TWIN BRIDGES SUBSTATION TRANSFORMER ADDITION

BID #2258-ADDENDUM #1, ACCEPTING BIDS TUESDAY, AUGUST 20, 2019

CITY OF ALEXANDRIA
ALEXANDRIA, LOUISIANA

DRAWING NO.: **TBTA-05** REV.: **B2**

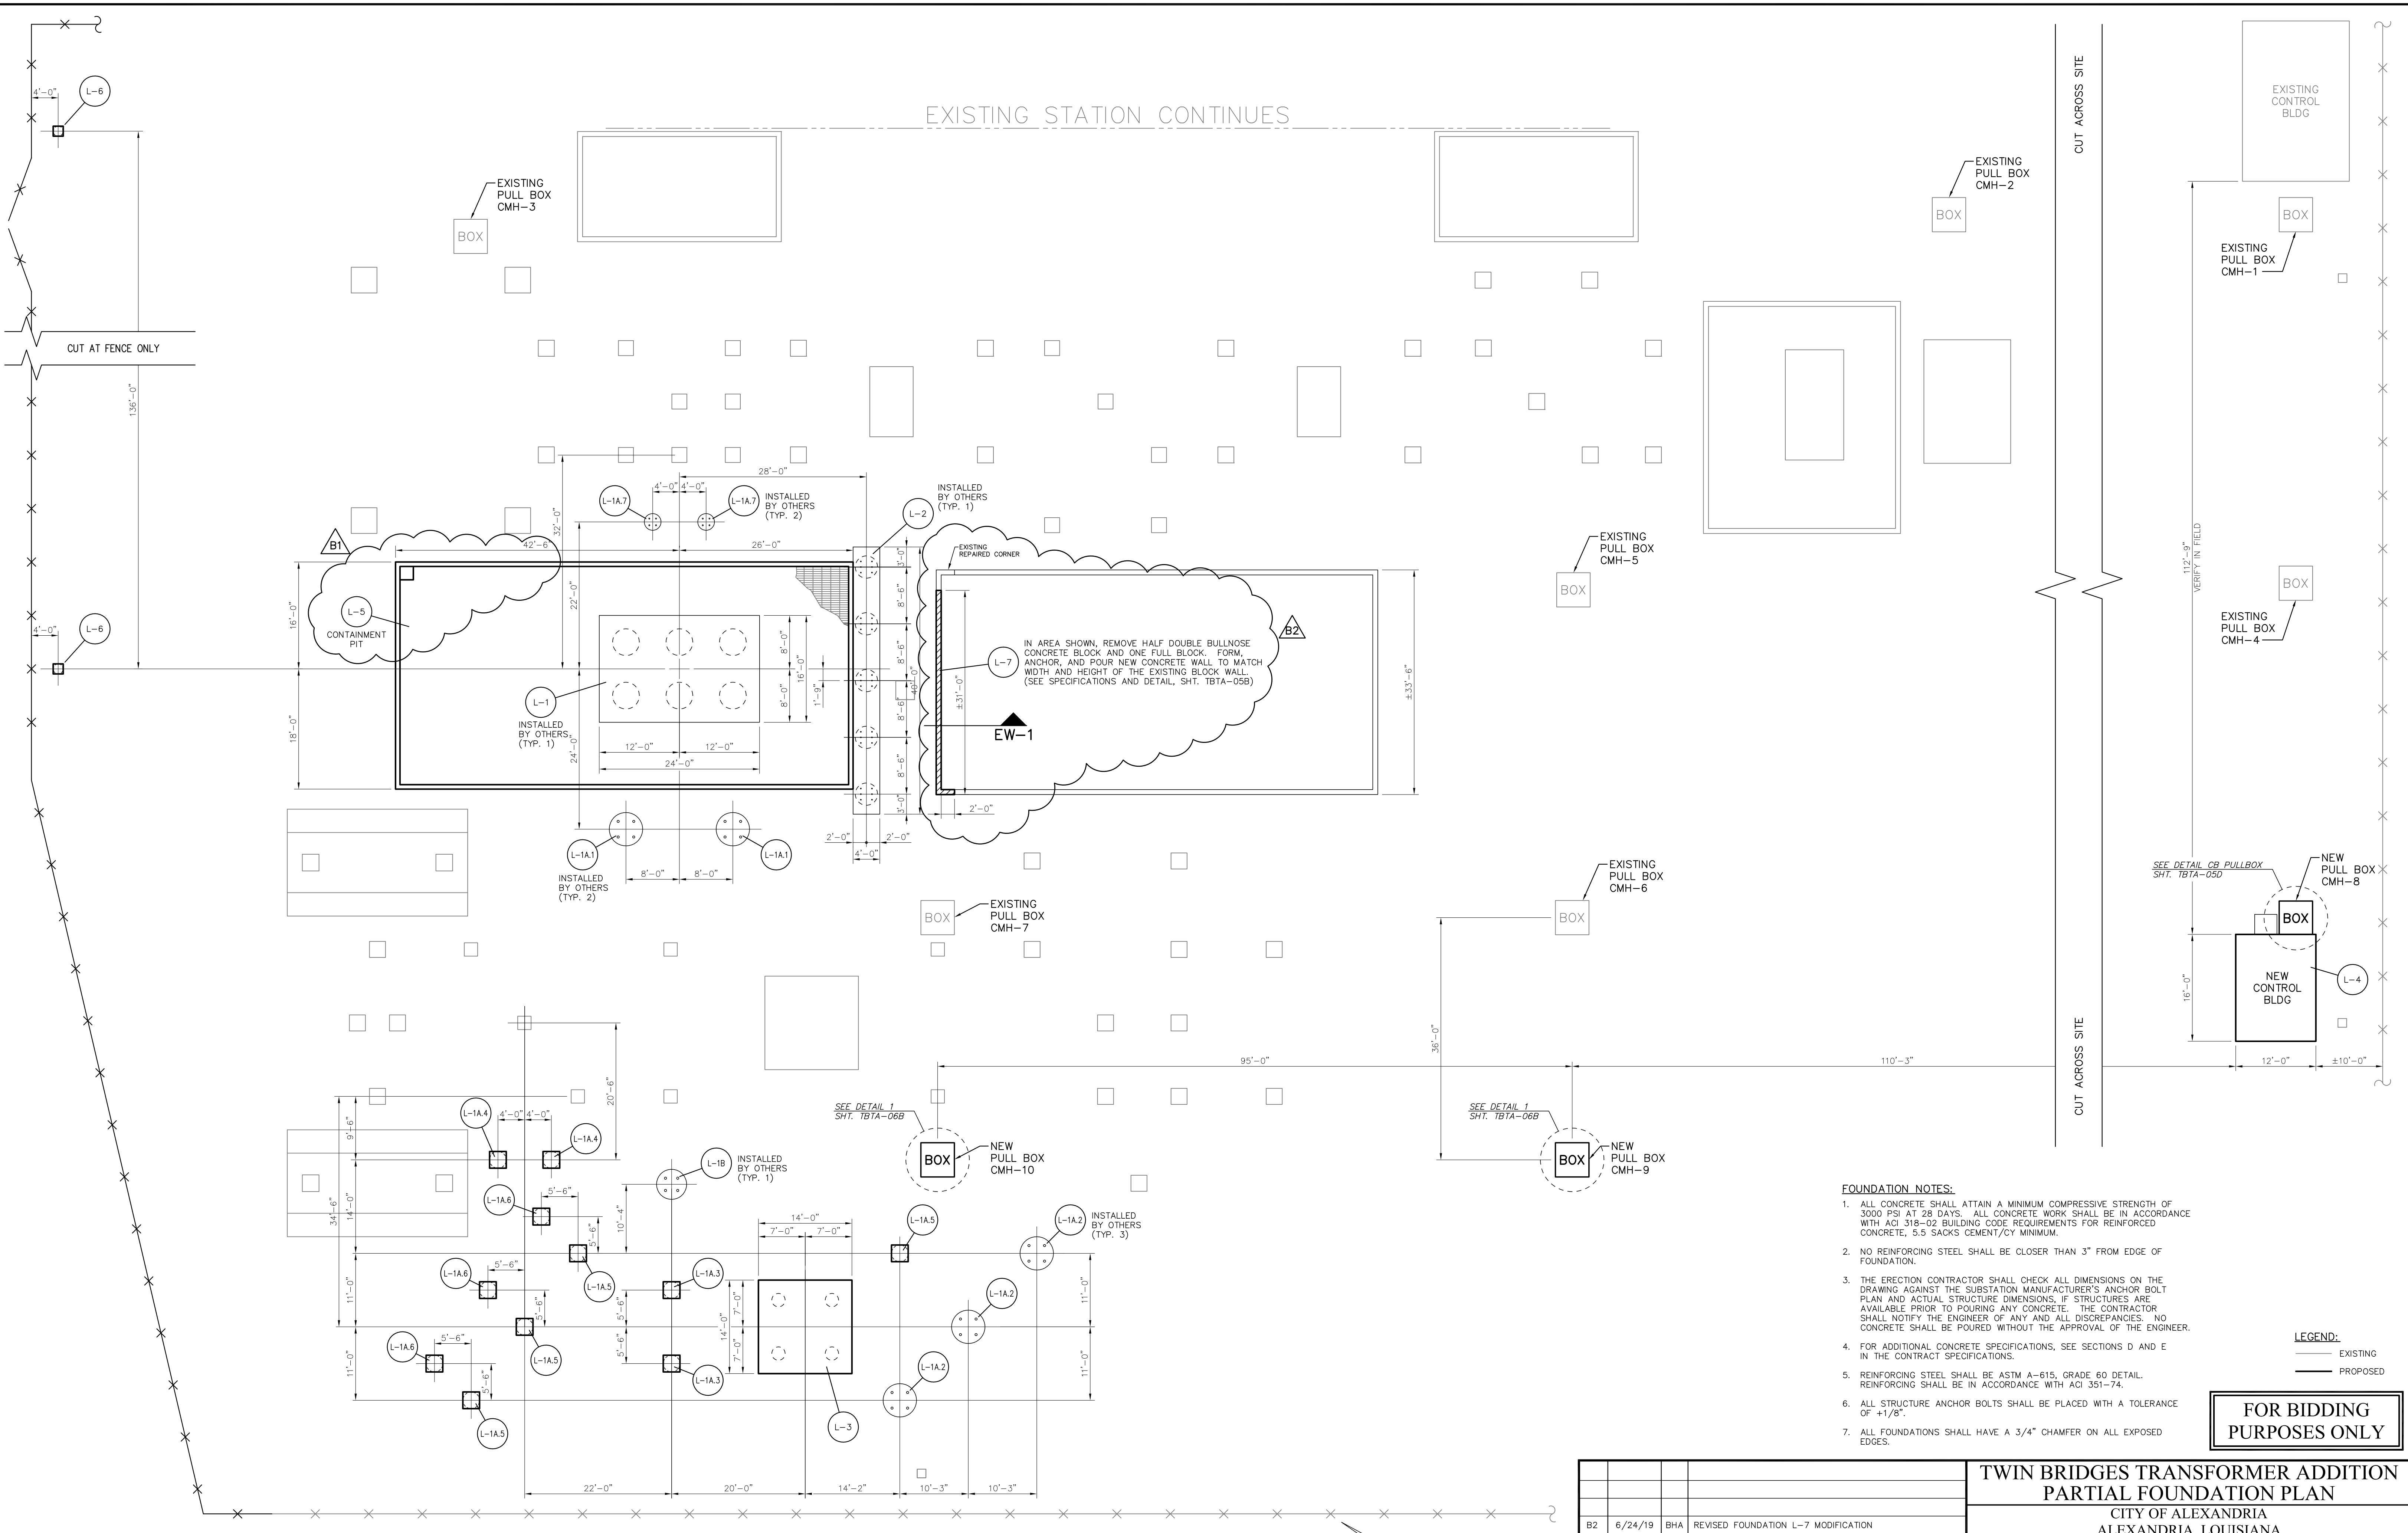
NO.	DATE	BY	REVISIONS
B2	6/24/19	BHA	REVISED FOUNDATION L-7 MODIFICATION
B1	6/5/19	BHA	REVISED CONTAINMENT PIT FOUNDATION
B	5/30/19	BHA	FOR BIDDING PURPOSES ONLY - CONSTRUCTION
A	3/4/19	BHA	FOR BIDDING PURPOSES ONLY - CONSTRUCTION

SCALE: NOTED	DATE: 12/19/18	DRAWN BY: JHD	APPROVED BY: JJC	PROJECT NO.: 2019-E-16A
BHA, INC. BATON ROUGE, LOUISIANA			DRAWING NO.: TBTA-05B	REV.: B2

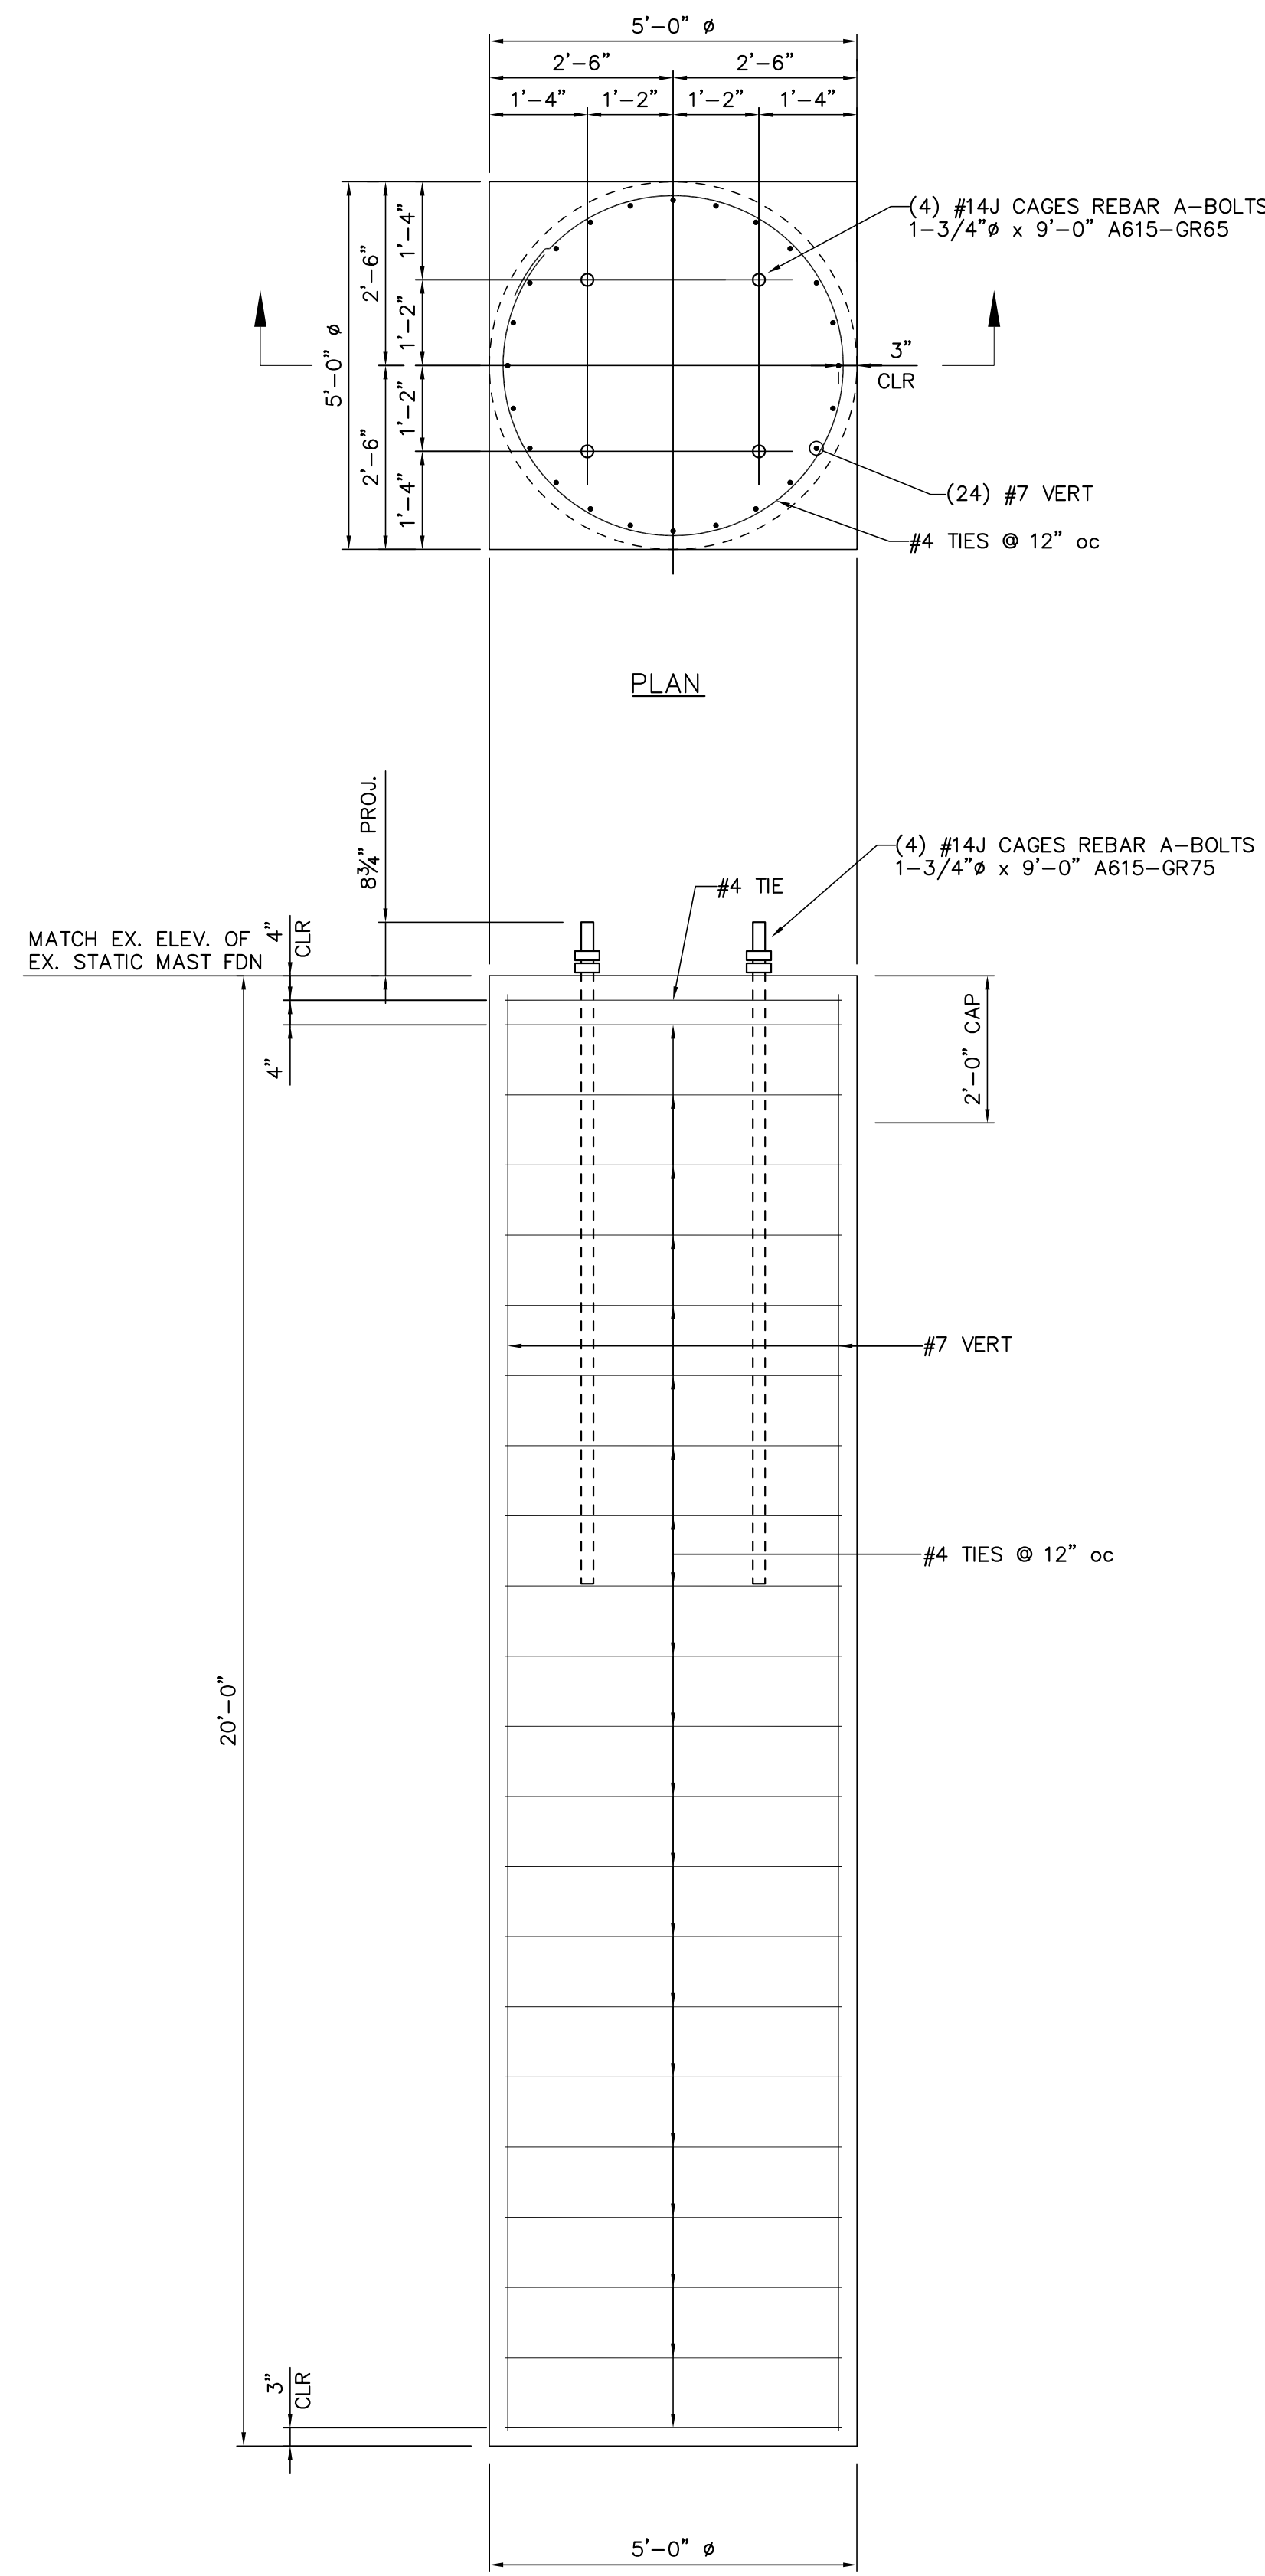
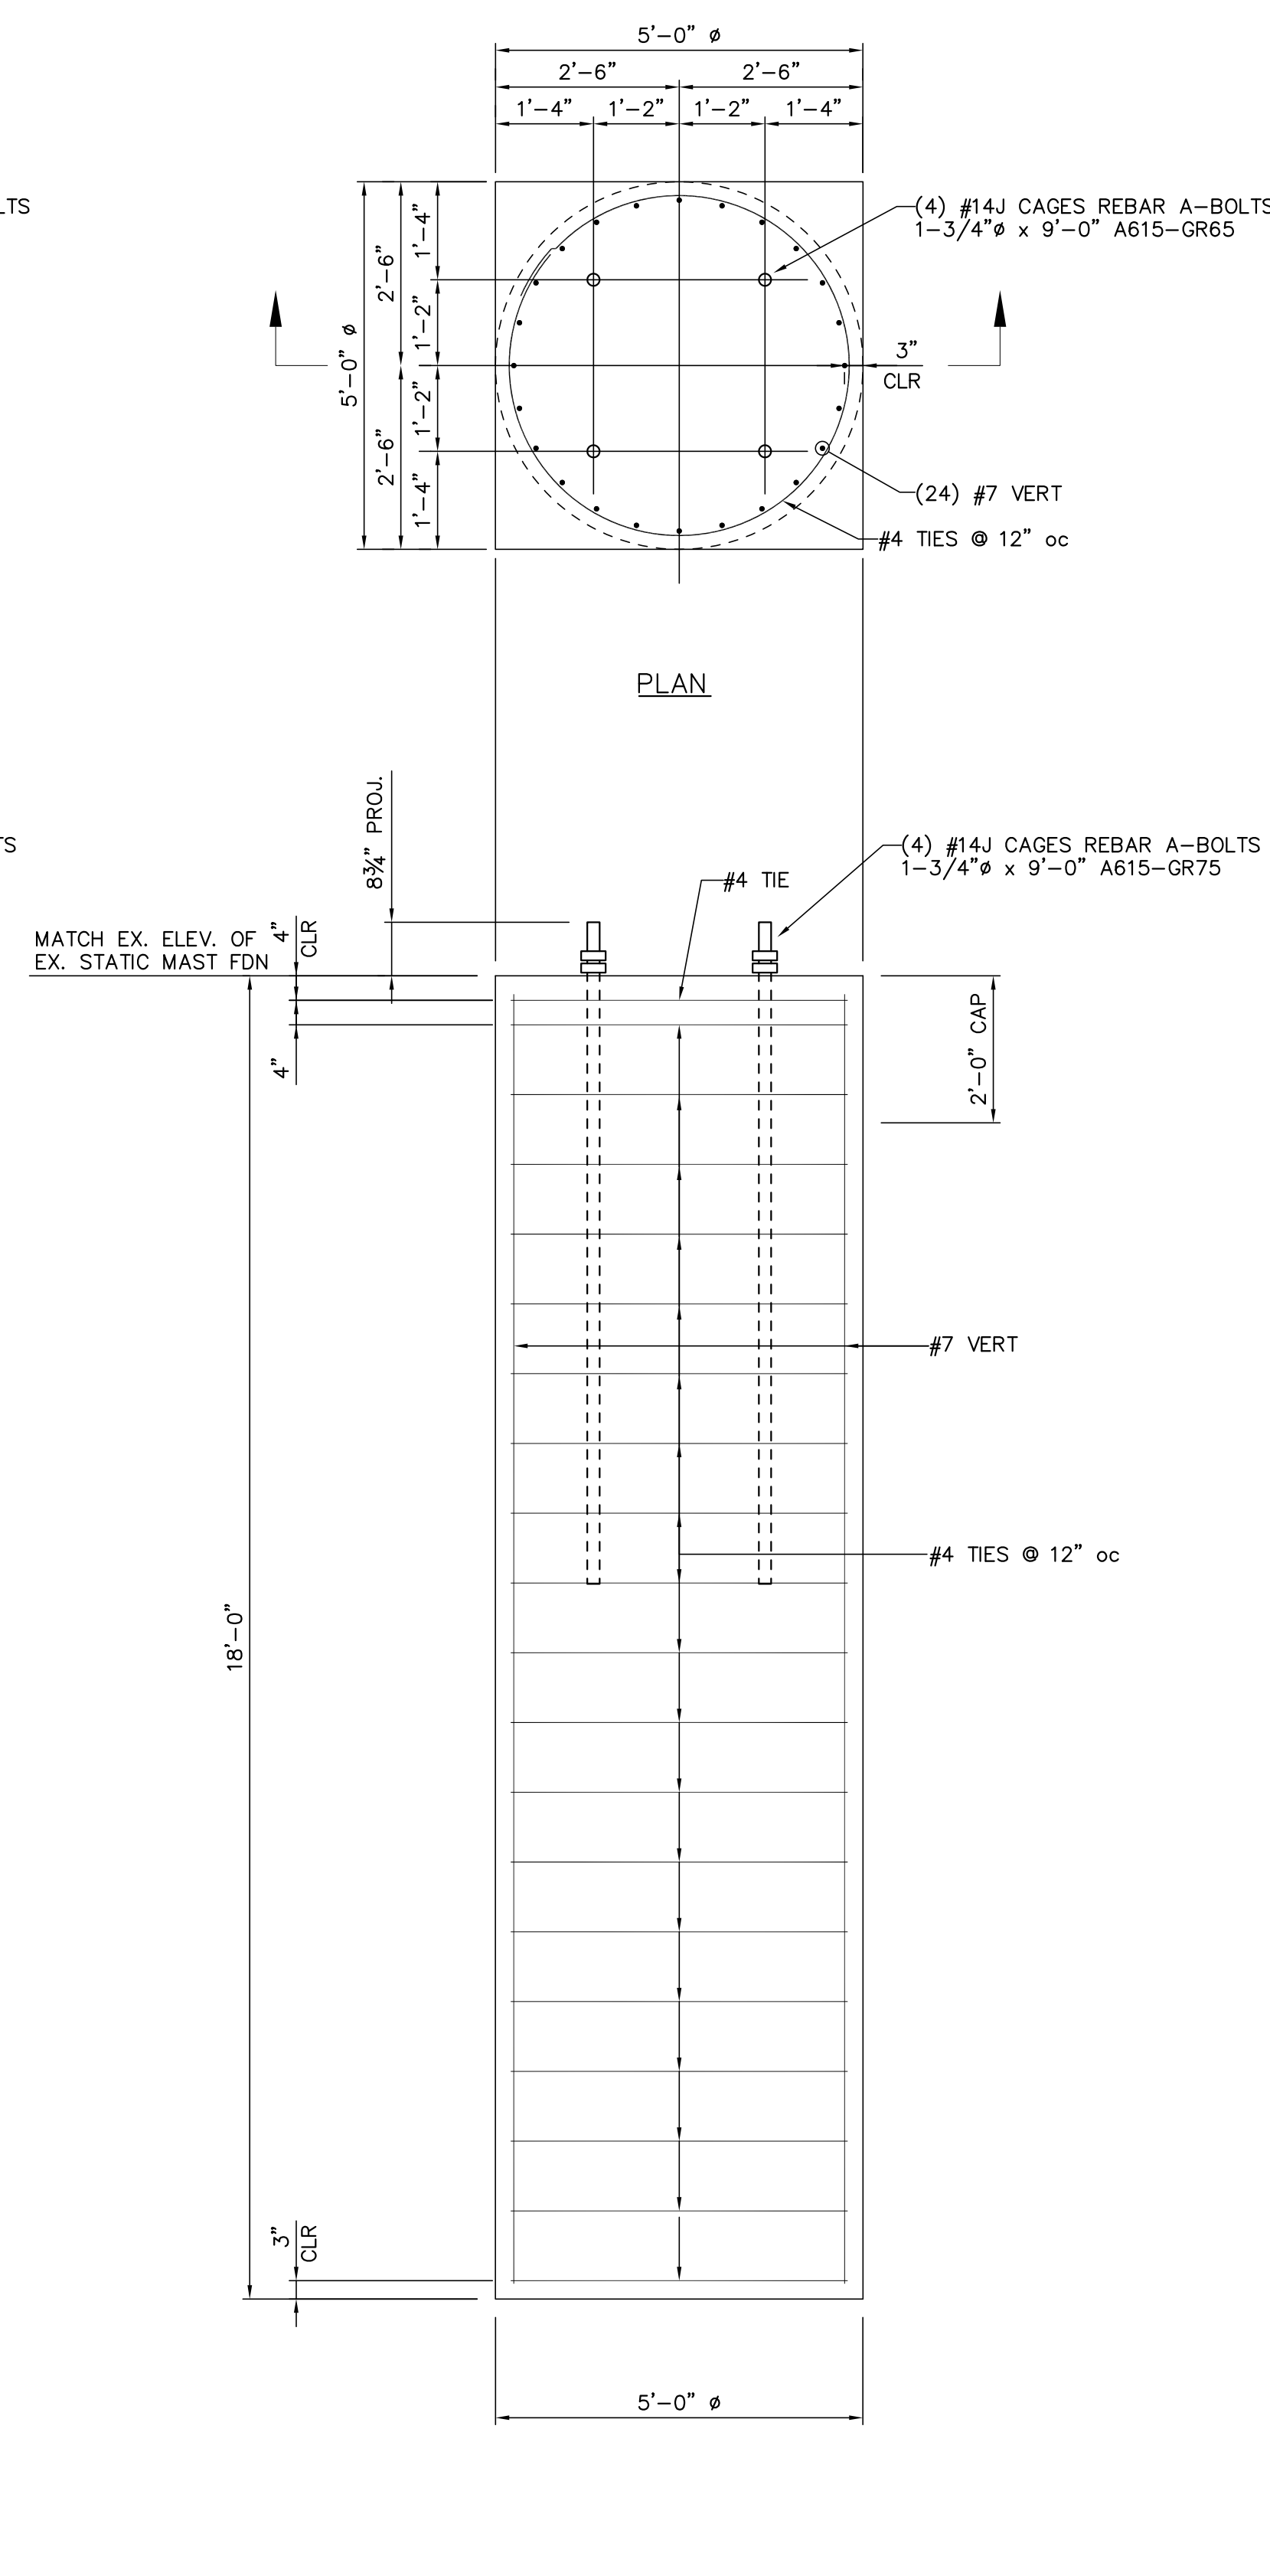
NO.	DATE	BY	REVISIONS
B2	6/24/19	BHA	REVISED DETAIL EW-1
B	5/30/19	BHA	FOR BIDDING PURPOSES ONLY
A	3/4/19	BHA	FOR BIDDING PURPOSES ONLY
